Error reporting

Tracker Week 01/2003

Presented by Pierre Van Hove

FE_HYBRID TO UTRI ADAPTER CARD

EDMS REF:318639	VERSION:4	PCB:EP 680-1174-400-C SYSTEM:		
REF: EP 680-1174-400-C		TITLE: FE_HYBRID TO UTRI / TEST ADAPTER CARD		
IT/CE 	DIV. EP	ABBREU:	PAGE: 1/1	
	1211 GENEVA 23	LAST_MODIFIED=Mon Sep 23 15:06:59 2002		
	SWITZERLAND	DESSIN: SANCHEZ M.	ETUDE: HAMMARSTROM	DATE: 03/07/00

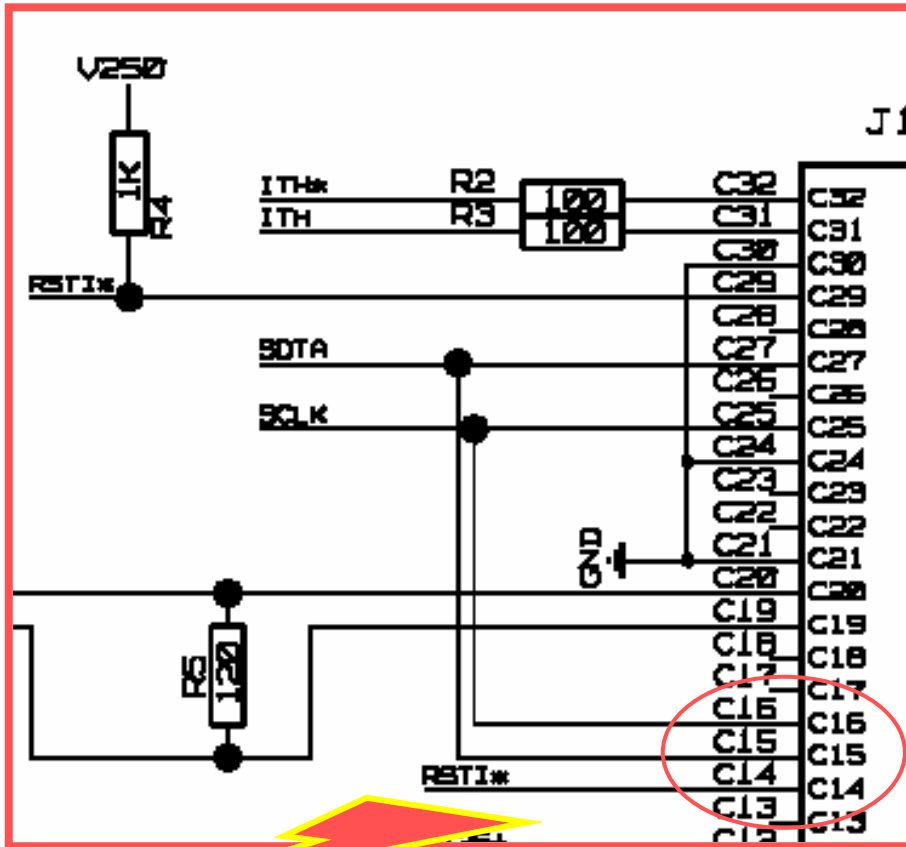
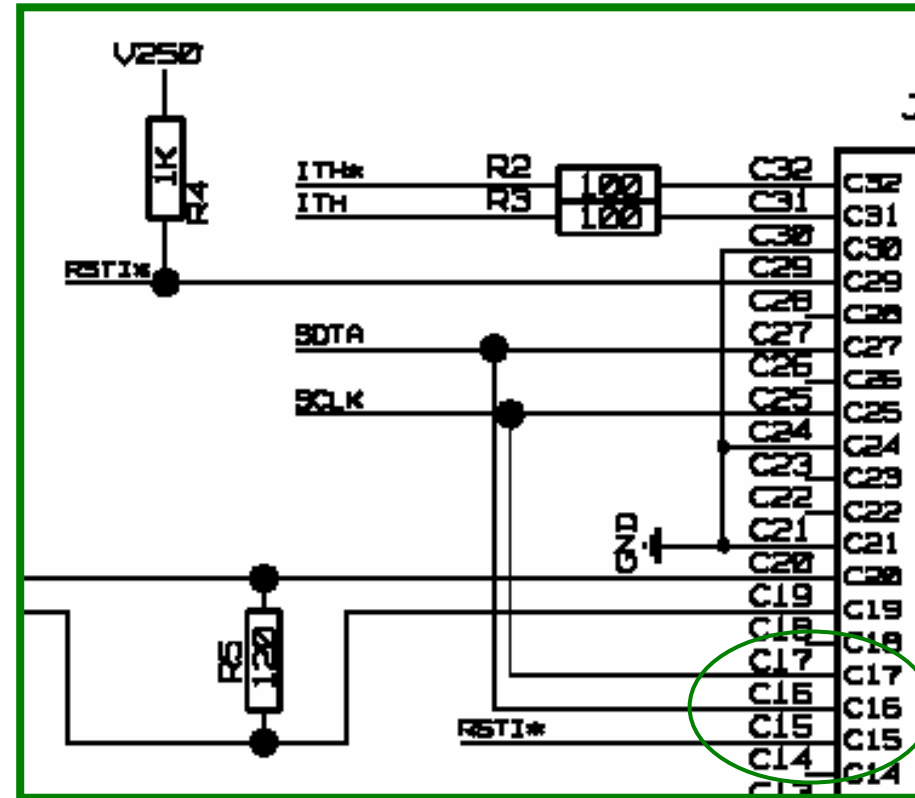
Bad because C14 is connected to V250 (in VUTRI)

➔ No (reliable) reset.

C15 and C16 connected to OHRST & OHSDA

➔ No problem if no opto-hybrid
